ADOLFSON & PETERSON, INC.
AURORA, COLORADO
HEADQUARTERS
FINAL DEVELOPMENT PLAN
SITE PLAN

ADOLFSON & PETERSON, INC.
NEW OFFICE/WAREHOUSE - AURORA HEADQUARTERS
LOCATED NEAR:
6th AVENUE and VENTURA STREET

APPROVED LS PLAN IMPROVEMENTS VS PROPOSED LS IMPROVEMENTS (MINOR AMENDMENT LS PLAN JUSTIFICATION DOCUMENT)

SITE PLAN
SCALE: 1" = 20'-0"

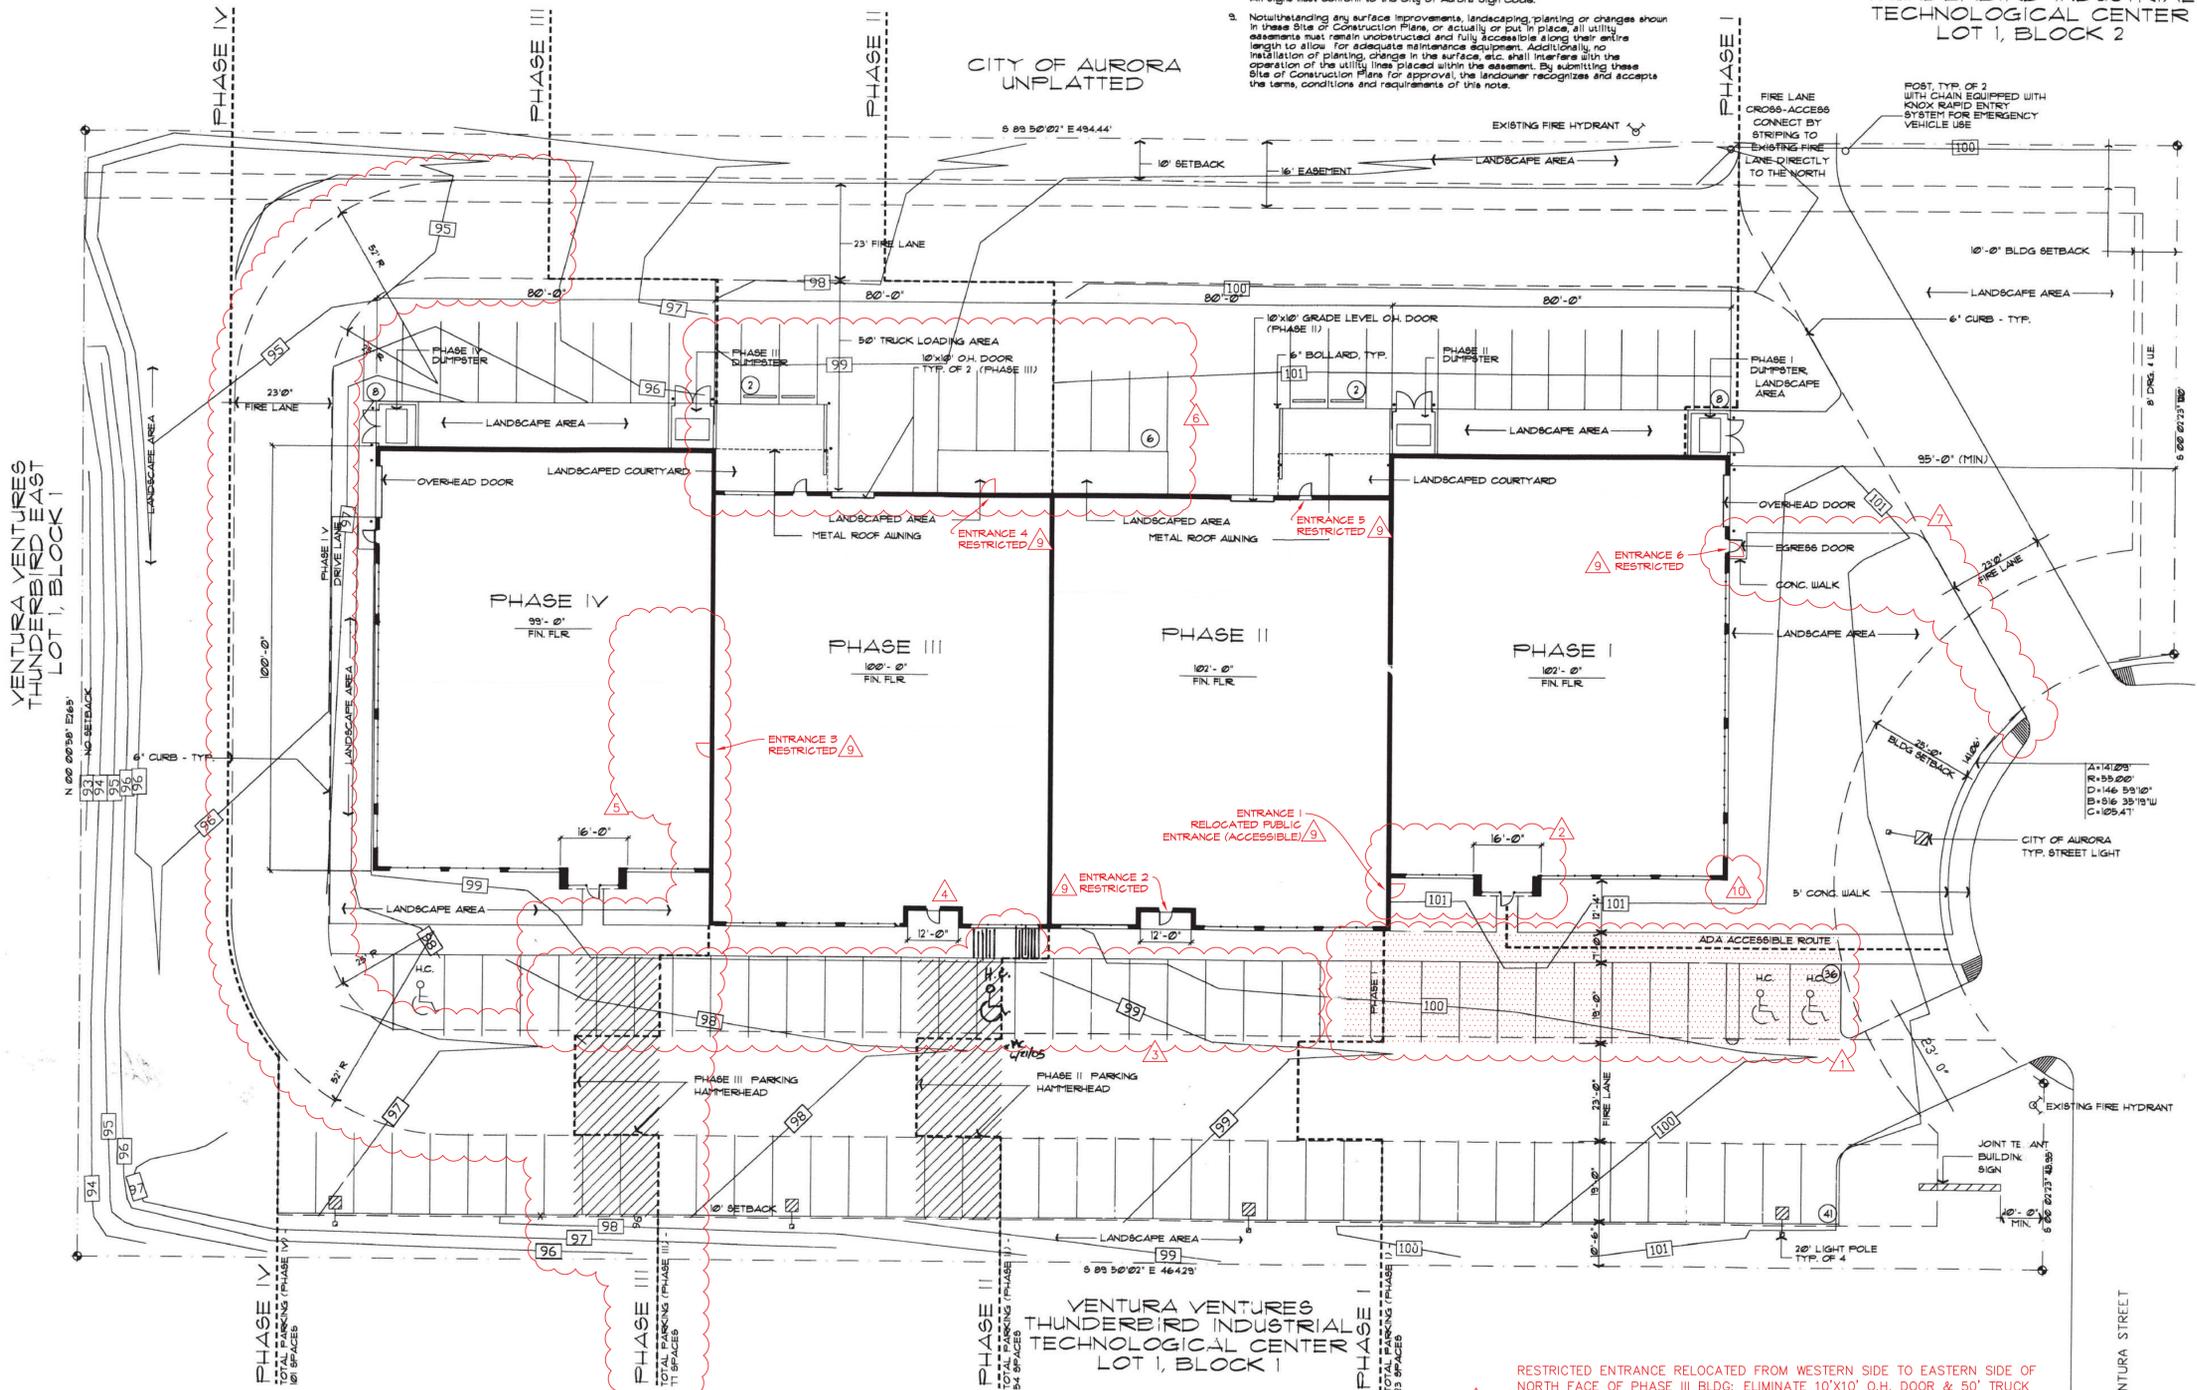
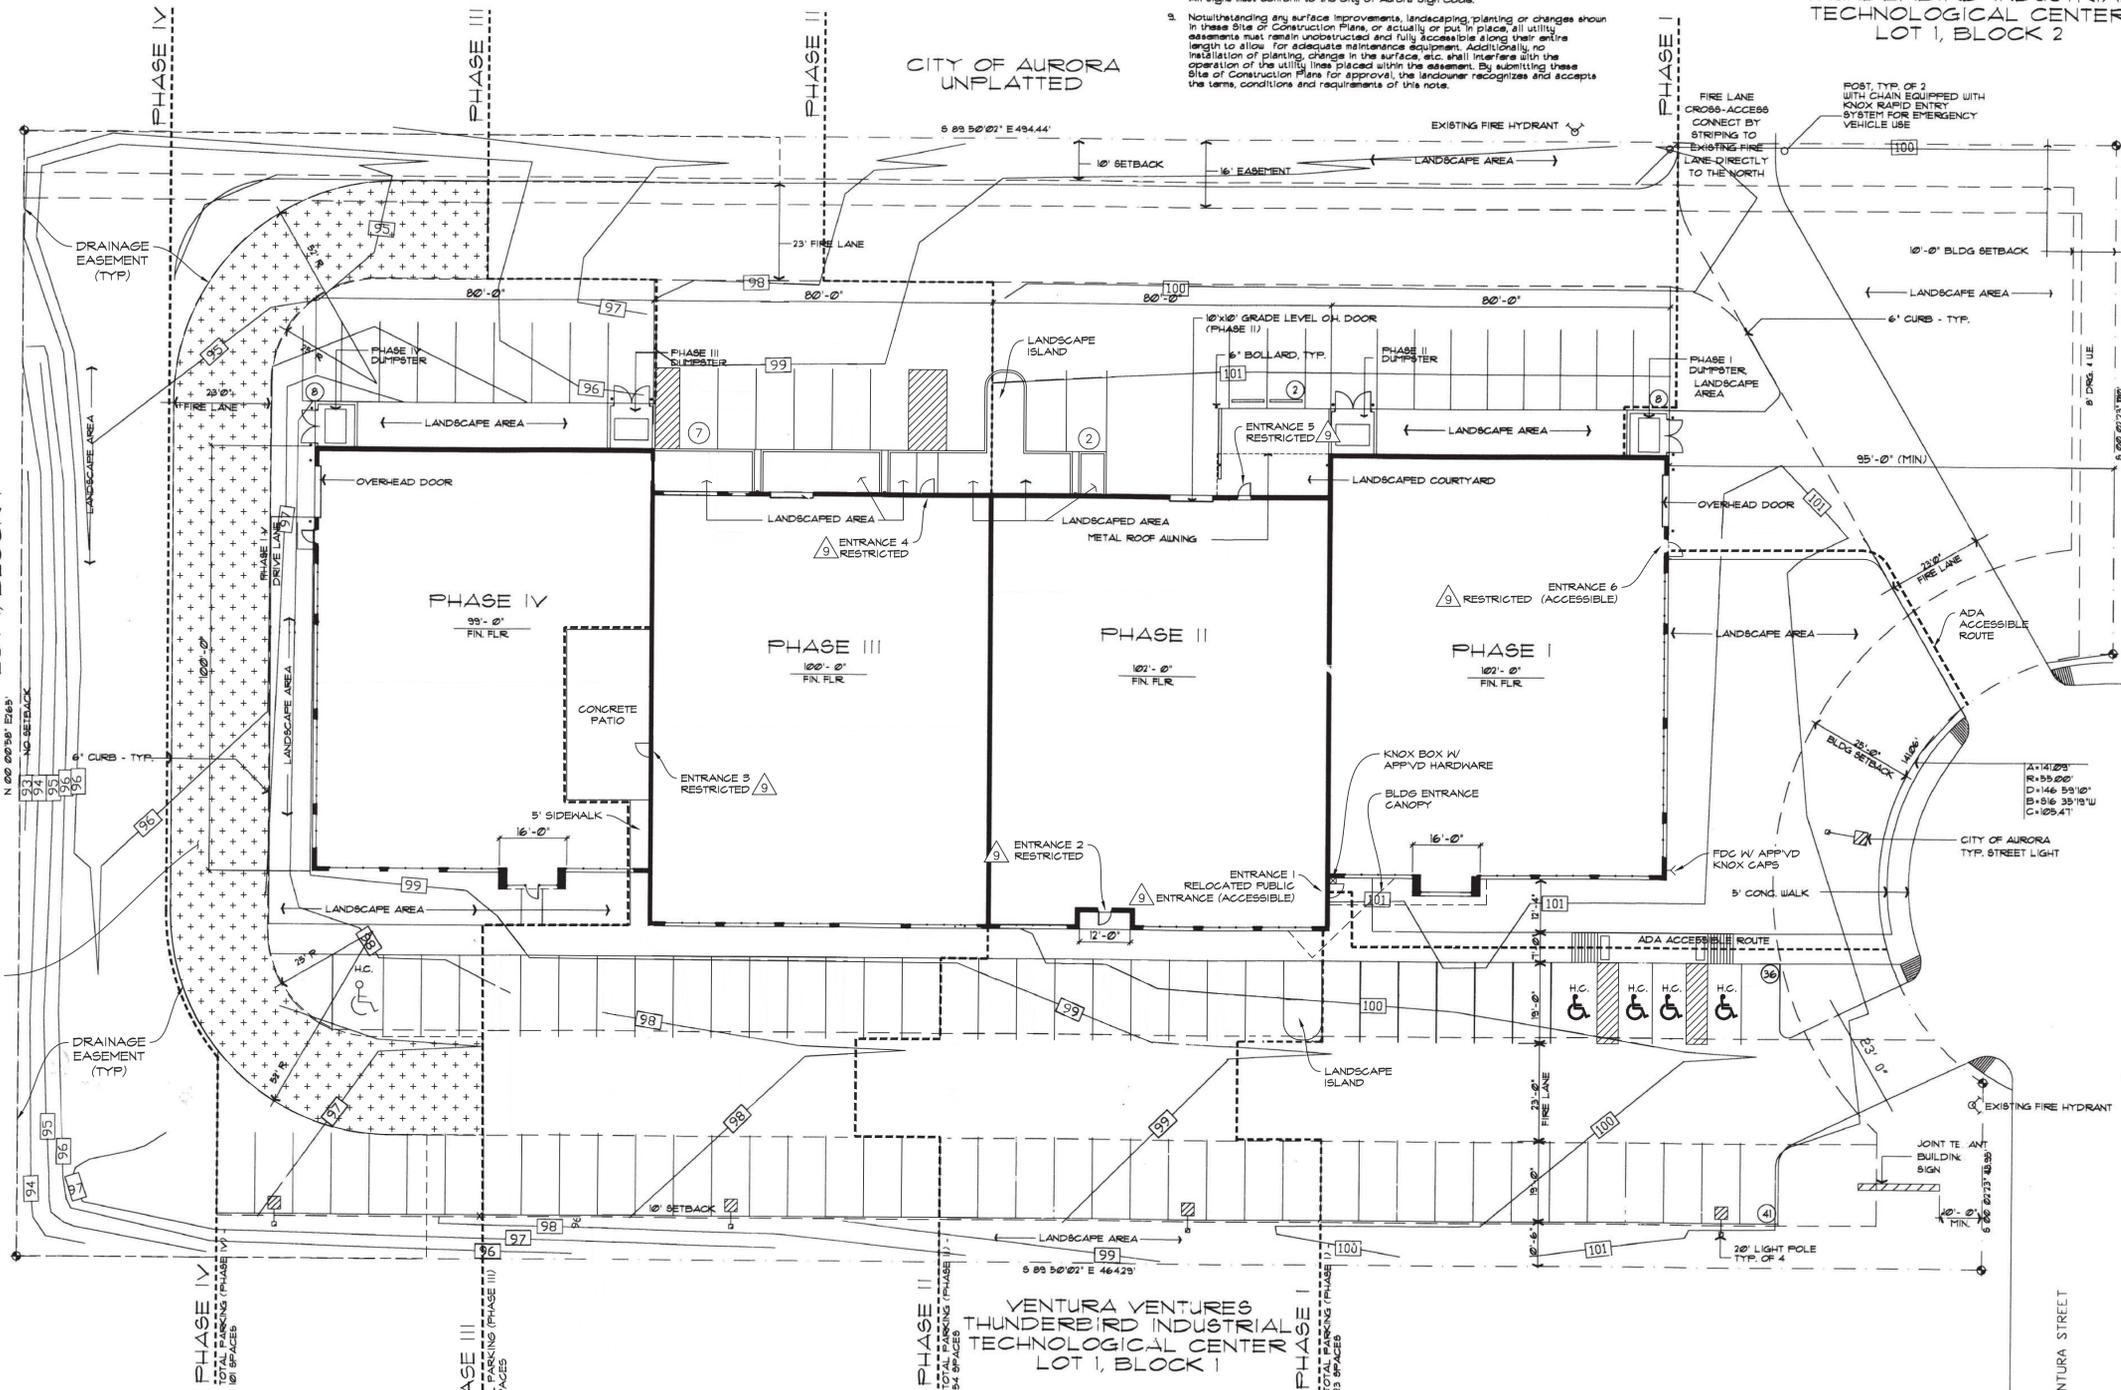
- △ HATCHING INDICATES APPROX LIMITS OF SIDEWALK & PAVEMENT REMOVAL/REPLACEMENT DURING PHASE III BLDG CONSTRUCTION FOR RELOCATED ADA PARKING STALLS & ADA RAMPS; REVISED ADA ACCESSIBLE ROUTE & ADDED LANDSCAPED ISLAND (9' WIDTH W/ CURB & GUTTER)

- △ RELOCATE PUBLIC ENTRANCE (ACCESSIBLE) FROM PHASE I BLDG TO EAST FACE OF PHASE II BLDG, INCLUDE SIDEWALK EXTENSION & BLDG ENTRANCE CANOPY AT RELOCATED PUBLIC ENTRANCE; REMOVE EXIST BLDG ENTRANCE SIDEWALK & REPLACE WITH LANDSCAPING; ADD KNOX BOX WITH APPROVED HARDWARE SYMBOL AT RELOCATED ENTRANCE - ADDED IN RESPONSE TO COA-LIFE SAFETY COMMENT

- △ RESTRIPE PARKING STALLS TO ACCOMMODATE REVISIONS TO PARKING EAST & WEST OF AREA; REMOVE EXIST ADA PARKING STALL & ADA RAMP (TO BE RELOCATED ON NORTHEAST END OF PARKING LOT)

- △ PHASE III RESTRICTED BLDG ENTRANCE ON SOUTH BLDG FACE ELIMINATED & BLDG LIMITS REVISED TO REMOVE ALCOVE
- △ RESTRICTED ENTRANCE, 20'X40' CONCRETE PATIO & 5' CONCRETE SIDEWALK (INTERIM-DURING PHASE III) ADDED TO WEST SIDE OF PHASE III BLDG; PHASE III PARKING HAMMERHEAD STRIPING REPLACED WITH EXTENSION OF FIRE LANE AROUND WEST SIDE OF PHASE IV BLDG TO COMPLETE FIRE LANE LOOP AROUND BLDG - ADDED FIRE LANE LOOP IN RESPONSE TO COA-LIFE SAFETY COMMENT IN LIEU OF PROVIDING 2 FIRE APPARATUS TURNAROUNDS

- △ RESTRICTED ENTRANCE RELOCATED FROM WESTERN SIDE TO EASTERN SIDE OF NORTH FACE OF PHASE III BLDG; ELIMINATE 10'X10' O.D.H. DOOR & 50' TRUCK LOADING AREA; RECONFIGURE LS AREAS & PARKING ALONG NORTH SIDE OF PHASE III BLDG (TO INCLUDE 9' WIDE LS ISLAND & 3 DRAINAGE PANS TO ACCOMMODATE ROOF DRAIN DOWNPOUTS)

- △ RESTRICTED ENTRANCE REVISED TO ACCURATELY SHOW DOOR SWING DIRECTION, ADA ACCESSIBLE ROUTE ADDED, LIMITS OF PAVED DRIVE ON EAST SIDE OF PHASE I BLDG TO BE REVISED TO REFLECT CONSTRUCTED LIMITS

- △ REVISED PHASE III PROVIDED PARKING STALLS (84) & PROVIDED ADA STALLS (4)
- △ SEE SHEET A4 FOR SITE ACCESSIBILITY REVIEW & JUSTIFICATION ITEMS (ACCESSIBLE ENTRANCES & PARKING)

- △ ADD FDC WITH APPROVED KNOX CAPS SYMBOL TO SITE PLAN - FDC EXISTS & SYMBOL ADDED IN RESPONSE TO COA-LIFE SAFETY COMMENT

HATCHING INDICATES APPROX LIMITS OF FIRE LANE EXTENSION IN PHASE III - ACCESS ROAD CONSTRUCTION SHALL BE DESIGNED & MAINTAINED TO SUPPORT THE INCREASED LOADS OF FIRE APPARATUS (25,000 LBS) UTILIZING THE CDOT CLASS 6 ROAD BASE SPECIFICATION TO PROVIDE FOR ALL WEATHER DRIVING CAPABILITIES. ACCESS ROAD SHALL BE 23' WIDE WITH A 24' INSIDE TURNING RADIUS. WHILE CDOT CLASS 6 BASE COURSE IS SPECIFIED, THE MATERIAL USED TO CONSTRUCT THESE SURFACES MAY BE OF ANY ONE OF OR A COMBINATION OF SEVERAL AGGREGATE MATERIALS AVAILABLE. APPROVED MATERIALS INCLUDE FINE-MIXED ROAD BASE MATERIAL, 1.5 ANGULAR INCH RIVER ROCK, CRUSHED GRANITE OR OTHER AGGREGATE WITH NOT LESS THAN ONE-INCH NOMINAL SIZE DESIGNATION & CDOT CLASS 6 ROAD BASE.

SITE ACCESSIBILITY-

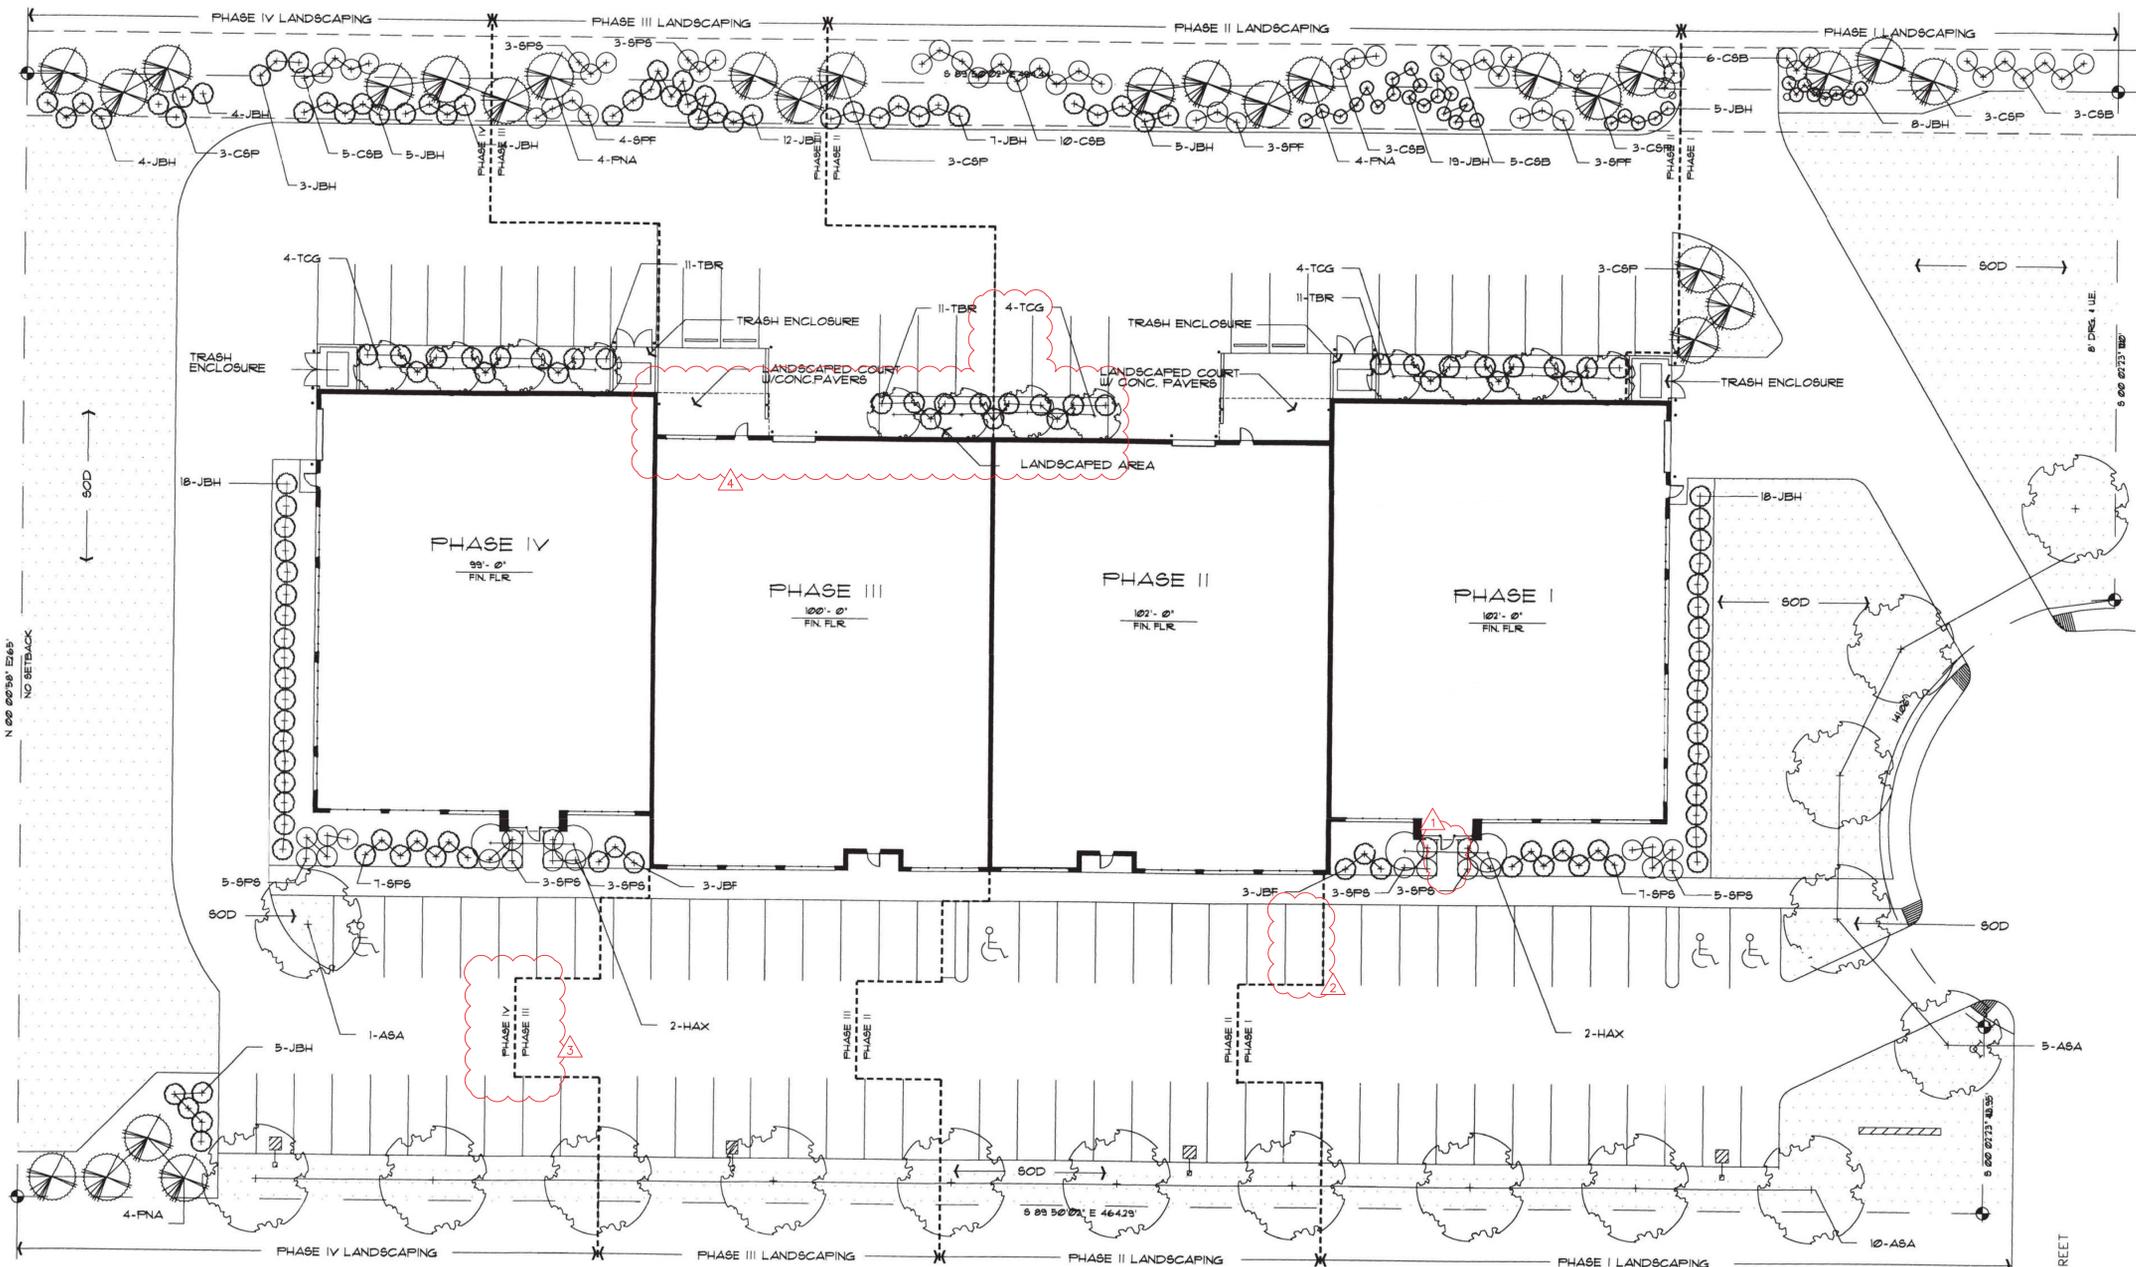
ACCESSIBLE PARKING:
 THE OVERALL PARKING PROVIDED THRU PHASE III IS 84 SPACES. PER 2015 IBC TABLE 1106.1, FOUR (4) OF THESE SPACES ARE REQUIRED TO BE ACCESSIBLE, INCLUDING ONE (1) VAN ACCESSIBLE SPACE (SEC. 1106.5).
 PER SEC. 1106.6, THE ACCESSIBLE PARKING SPACES SHALL BE LOCATED ON THE SHORTEST ACCESSIBLE ROUTE OF TRAVEL FROM ADJACENT PARKING TO AN ACCESSIBLE BUILDING ENTRANCE. DUE TO THE EXISTING PAVING, SIDEWALK & DRAINAGE PAN GRADES ALONG THE SOUTH OF THE BUILDING, THE PARKING SPACES CLOSEST TO ENTRANCE 1 DO NOT MEET THE SLOPE REQUIREMENTS OF ACCESSIBLE PARKING SPACES (2017 ICC/ANSI A117.1 SEC. 502.5). THE PROVIDED ACCESSIBLE PARKING SPACES ARE LOCATED AT THE NORTHEAST END OF THE PARKING LOT, WHICH IS FLATTER AND COMPLIES WITH THE SLOPE REQUIREMENTS OF 2017 ICC/ANSI A117.1 SEC. 502.5.
